Subject: AP1000 Response to Request for Additional Information (TR 85)

Response to Request for Additional Information on Technical Report No. 85

RAI Response Number: RAI-TR85-SEB1-32  
Revision: 2

Figure RAI-TR85-SEB1-32-1  
Comparison of Vertical Stress at Basemat Bottom Node – No embedment

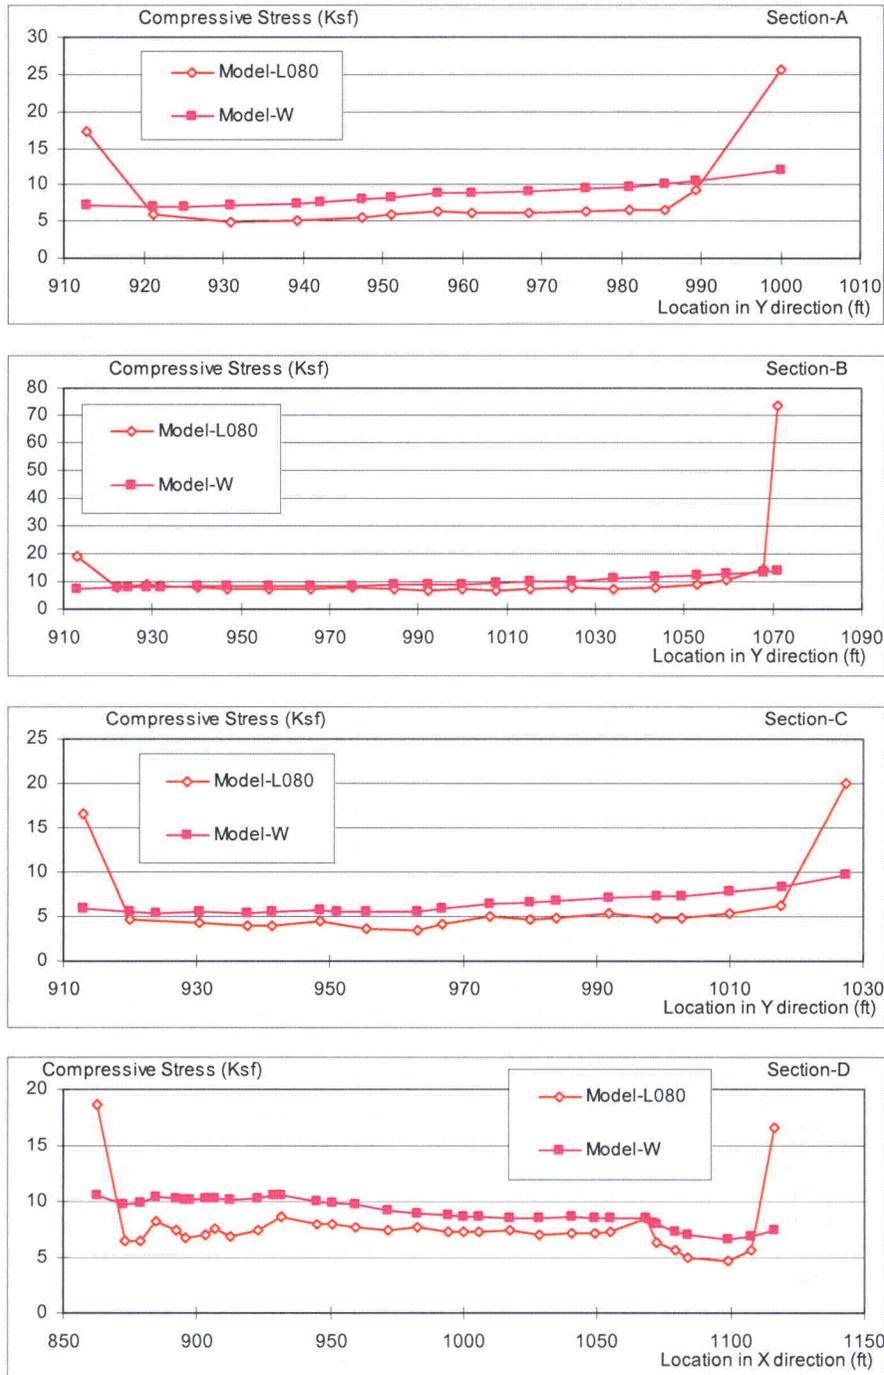
As shown by the studies in Section 2.7.1.2.1, when the soil is represented as solid elements rather than Winkler soil springs, higher bearing pressures occur at the edges and lower bearing pressures away from the edges. This is referred to as the effects of the Boussinesq distribution. Although this indicates that the basemat slab away from the walls would have higher bearing pressures using the Winkler soil spring approach (see Figure 2.7-2), the calculation of the maximum bearing pressure would still exist at the building edges if the soil is modeled as solid elements. Therefore, explain why the maximum bearing pressure for the AP1000 design, discussed in Section 2.4.2, should be based on the 2D ANSYS nonlinear dynamic analysis using Winkler soil springs rather than solid soil elements?

2. As noted in the original RAI, the studies in Section 2.7.1.2.1 demonstrate that when the soil is represented as solid elements, higher bearing pressures occur at the edges than when uniform Winkler type soil springs are used. This is a well known behavior in soil mechanics and is referred to as the Boussinesq effect. Since the current dynamic soil bearing pressure demand criterion of 35 ksf is still based on the 2D ANSYS stick model analysis, Westinghouse is requested to either (1) justify the statement that the localized peak soil pressures will redistribute if local stresses in the soil are excessive and the NI will still be stable or (2) explain what is the technical basis for using a uniform soil spring representation rather than soil brick

Figure RAI-TR85-SEB1-32-1 shows bearing pressures due to dead load. The sections are located as shown in Figure 2.7-2 of the technical report. The RAI figure only shows the two cases identified above. The finite element soil model shows high local bearing pressures close to the edge. This is due to the Boussinesq effect. The higher pressures at the edge result in lower pressures away from the edge. Figures RAI-TR85-SEB1-32-2 and 3 show bending moment contours MX and MY for these two cases. It is seen that the bending moments for the soil spring case are higher than those for the soil finite element model even in the bays immediately adjacent to the edge.
